1215 Ocean Blvd
Memo re 2nd Driveway Entrance/Exit

July 8, 2019

Re: Samonas – Septic Design
1215 Ocean Boulevard
Rye, NH
FES #1867

LOT LOADING CAPACITY CALCULATION

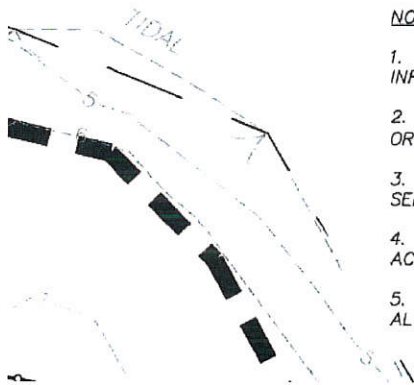
The attorney for the applicant has stated in the most recent submittal letter dated June 28, 2019 “Applicant’s 8-unit proposal enhances the wetland and wetland buffer, reduces the impervious coverage, improves drainage, meets flood requirements and supports the proposed units and septic.” FES has reviewed the design and finds that the lot loading is not sufficient for 16 bedrooms.

The septic plan proposed by the applicant dated March 26, 2019 by Altus Engineering NHDES-SSB Site Plan Sheet SS-1. The plan has a “LOT LOADING CAPACITY CALCULATION”. The calculation indicates the area of the lot minus the very poorly drained soils is 1.52 acres and the sewage loading factor for group 3 soils with 0-8% slopes is 1.6. The lot loading is the acreage x 2000 gpd / 1.6 = 1,900 gallons per day. The calculation goes on to “Municipal water supply-2.0” and doubles the lot loading to 3,800 gallons per day. This doubling of the lot loading capacity is incorrect.

It appears that Altus Engineering has mis-interpreted New Hampshire Code of Administrative Rules section Env-Wq 1005.03 Minimum Lot Sizes (f) For individual lots served or proposed to be served by an on-site ISDS and a public water system the lot size shall be at least 50% of the size shown in table 1005-1 or 20,000 ft² whichever is greater. This is not intended to allow lot loading to be doubled because the lot is serviced by a public water supply. The benefit of being supplied by public water is that there is no well radius to remove from the lot area. Env-Wq 1005.03 (f) is only applicable for subdivision of lots and does not apply to lot loading.

The lot loading for this lot is 1900 gallons per day. Bedrooms are 150 gallons per day. Therefore the maximum number of bedrooms for this site is 12 (1800 gallons per day).

Again, if the usable land of 1.52 acres is provided - then the parcel of land would be able to support maximum flow of 1900gpd. But the other example with a bit of unusable land, then 1.07 acres would not support the 16 bedrooms. The "municipal water supply – 2.0 factor" is not granted for doubling the lot loading calculations. Env-Wq 1005.03(f) under the "Minimum Lot Sizes" applies to subdivision applications.
